UNITED STATES PATENT AND TRADEMARK OFFICE

APPLICATION NO.	FILING DA	ATE	FIRST NAMED INVENTOR	ATTORNEY DOCKET NO.	CONFIRMATION NO.
10/606,210	06/26/2003		Yoshikazu Hanada	Q76020	4368
23373	7590 0	7/14/2005		EXAMINER	
	E MION, PLLC	ADDISU, SARA			
SUITE 800	SYLVANIA AV	ENUE, N.W.		ART UNIT	PAPER NUMBER
WASHING	TON, DC 2003	7		3722	
				DATE MAILED: 07/14/200	5

DETAILED ACTION

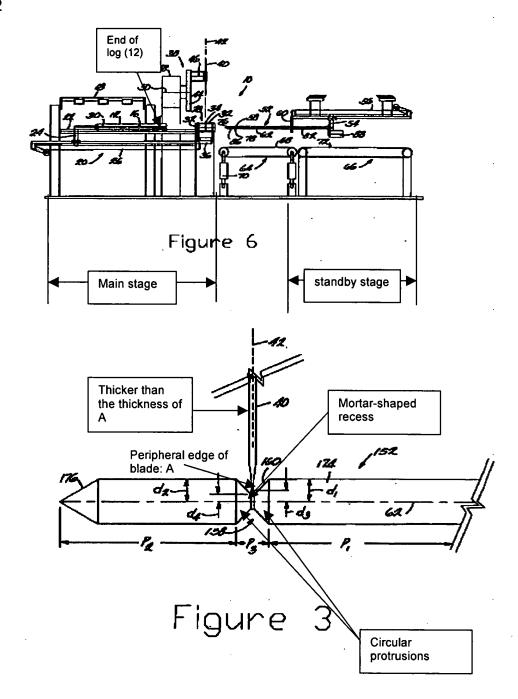
Regarding claim 16, Butterworth teaches a the cutting mandrel (52) comprising a central shaft (main pipe) (74) and a plurality of mandrel pieces sequentially inserted around the main pipe (i.e. sleeves 82) each mandrel piece having a mortar-shaped recess on its edge and a circular protrusion, and when the mandrel pieces are sequentially inserted around the central shaft (main pipe) (74), the leading tips of the protrusions come in contact with each other so that a gap to form grooves at the outer peripheral ends of the mandrel pieces (see figures below).
